CITY PLAN COMMISSION

FILE NUMBER: S234-031

REQUEST: An application to create one 0.924-acre lot and one 10.956-acre lot from a 11.88-acre tract of land in City Block A/8039 on property located on Buckner Boulevard, south of R. L. Thornton Freeway/ Interstate Highway No. 30.

PRELIMINARY PLAN
HOME DEPOT BUCKNER ADDITION
 LOT 1 AND LOT 2, BLOCK A-8039
 BEING A 11,880 ACRE TRACT OF LAND
 WILLIAM CHENault SURVEY, ABSTRACT NO. 276
 CITY OF DALLAS, DALLAS COUNTY, TEXAS
 CITY PLAN FILE NO. S234031

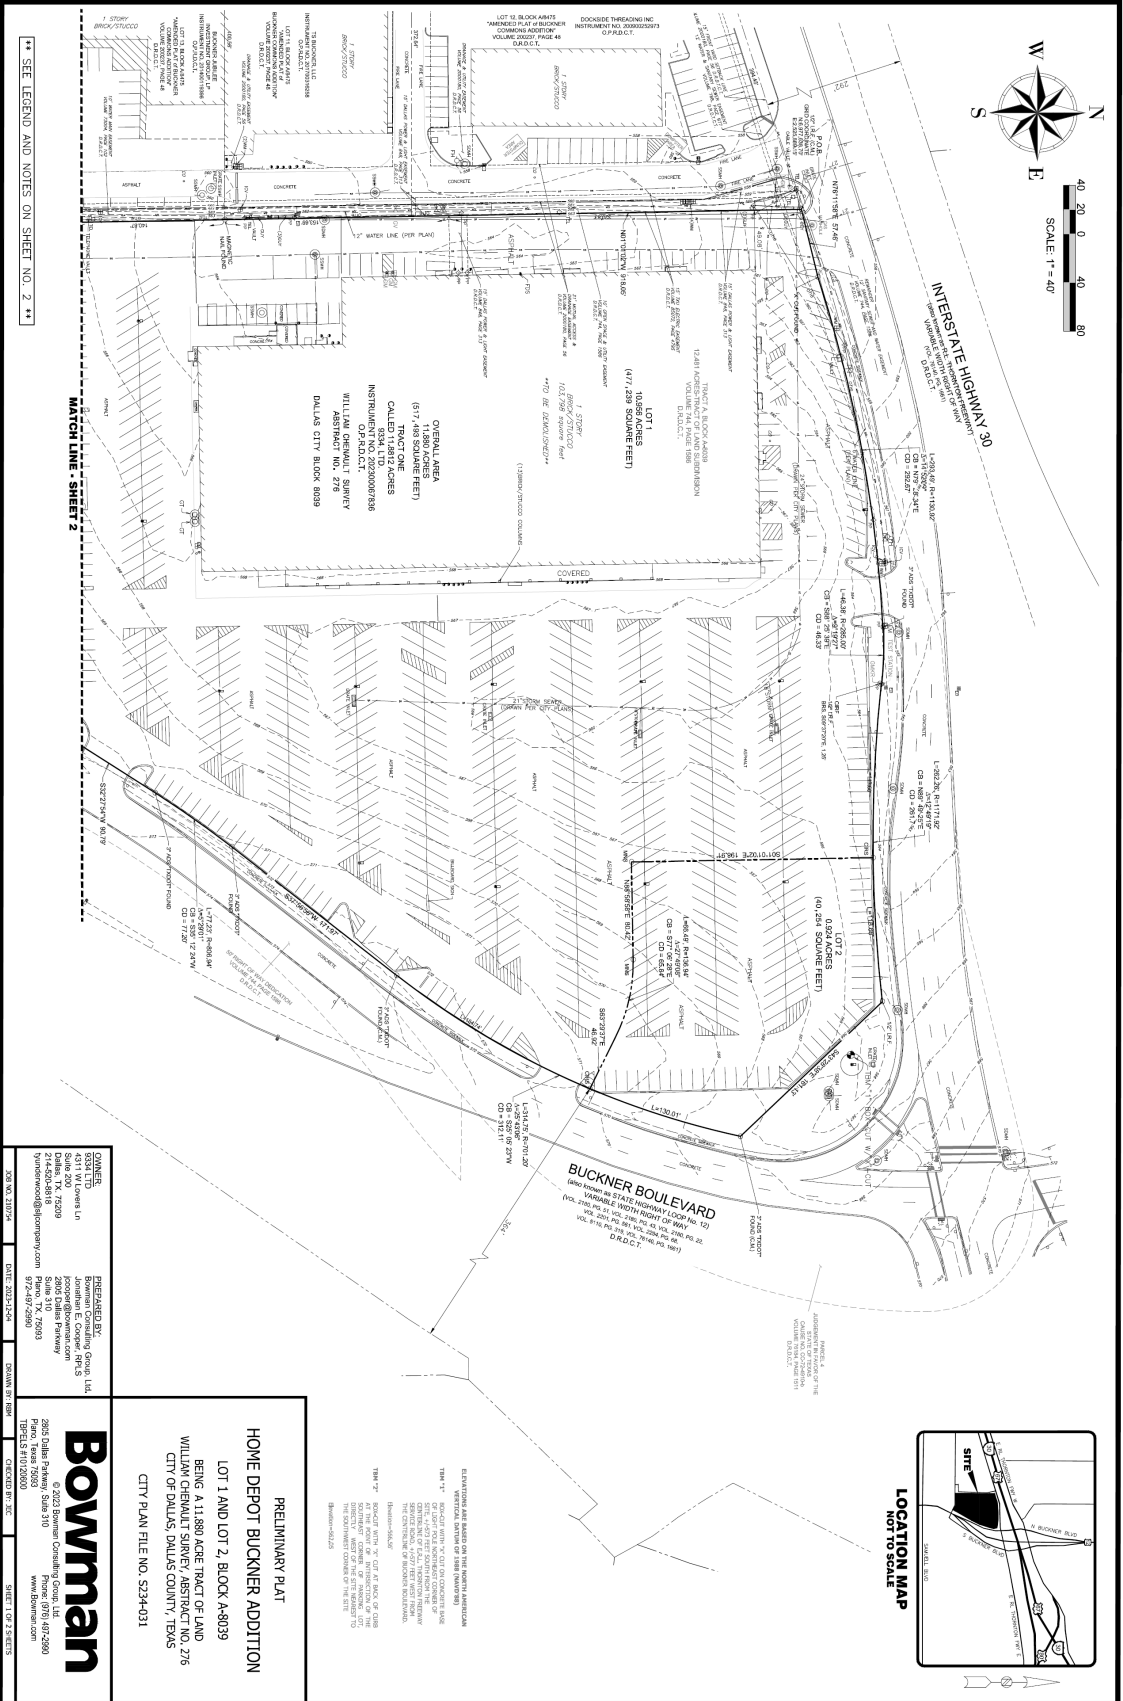
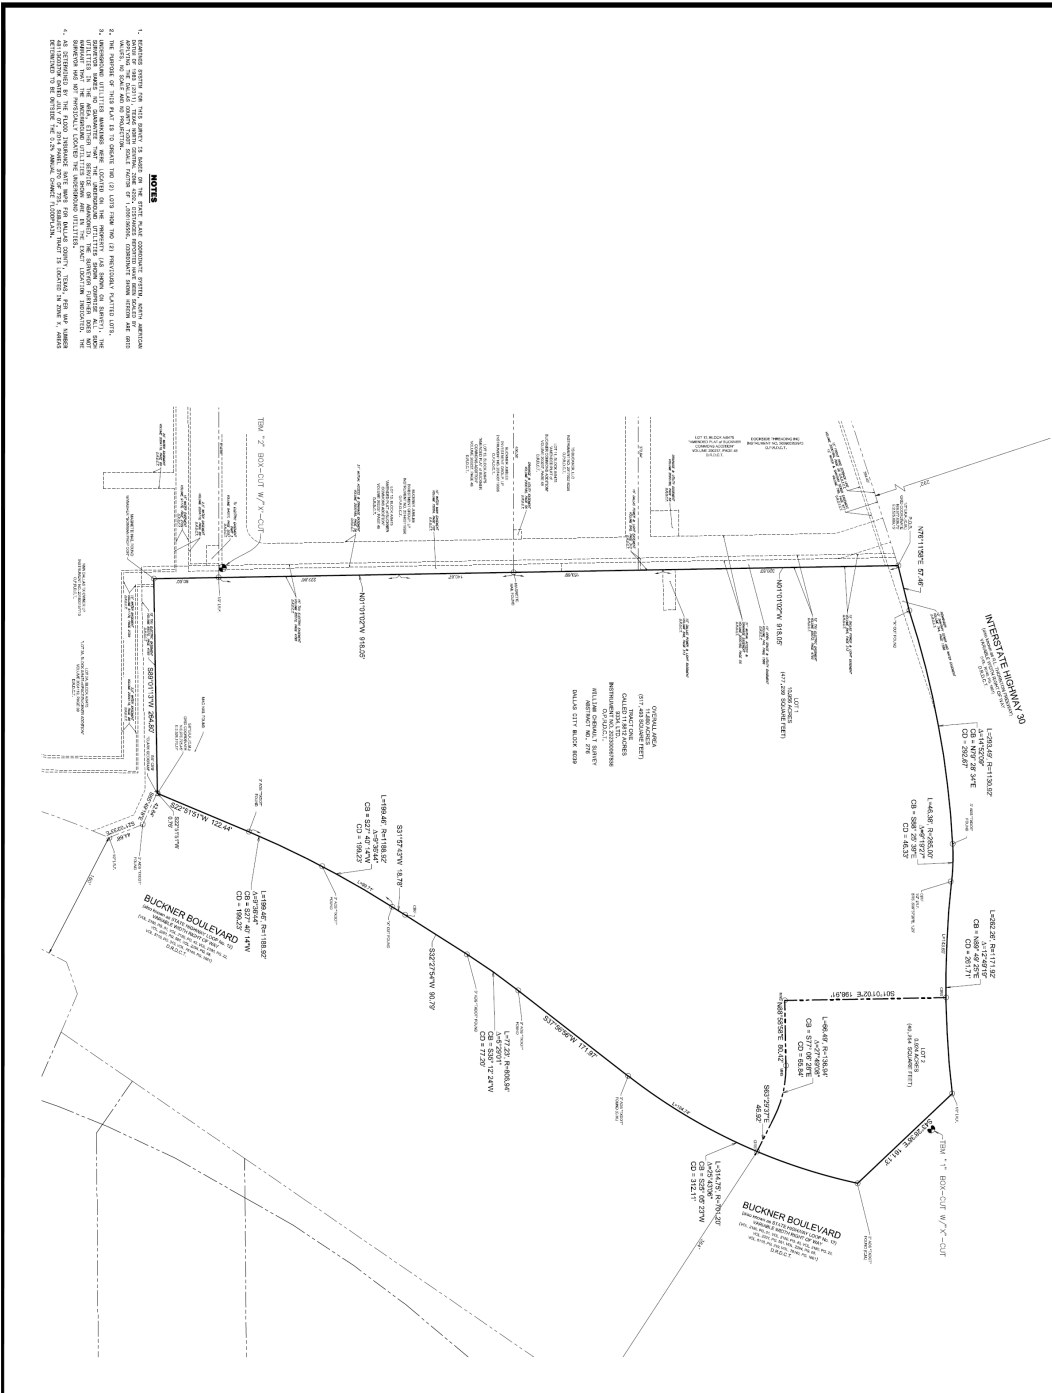
15. On the final plat, dedicate 53.5 feet of right-of-way (via fee simple) from the established center line of Buckner Boulevard /State Highway Loop No. 12. *Section 51A 8.602(c)*
16. TxDOT approval may be required for any driveway modification or new access point(s).
17. Existing drainage conveyance within the property is required to be sized in compliance with Section 51A-8.611(a)(1) of the City of Dallas Code.
18. Must coordinate with Transportation Department for any traffic signal requirements that are deemed necessary for improving pedestrian accessibility and safety related to site development. (Contact Srinivasa Veeramallu with Traffic Signals) Section 51A-8.606, 51A-8.608

25. On the final plat, change “Interstate Highway 30 (also known as R.L. Thornton Freeway)” to “R. L. Thornton Freeway/ Interstate Highway No. 30”.
26. On the final plat, change “Buckner Boulevard (also known as State Highway Loop No. 12)” to “Buckner Boulevard /State Highway Loop No. 12”.
27. On the final plat, identify the property as Lots 1A and 1B in City Block A/8475.
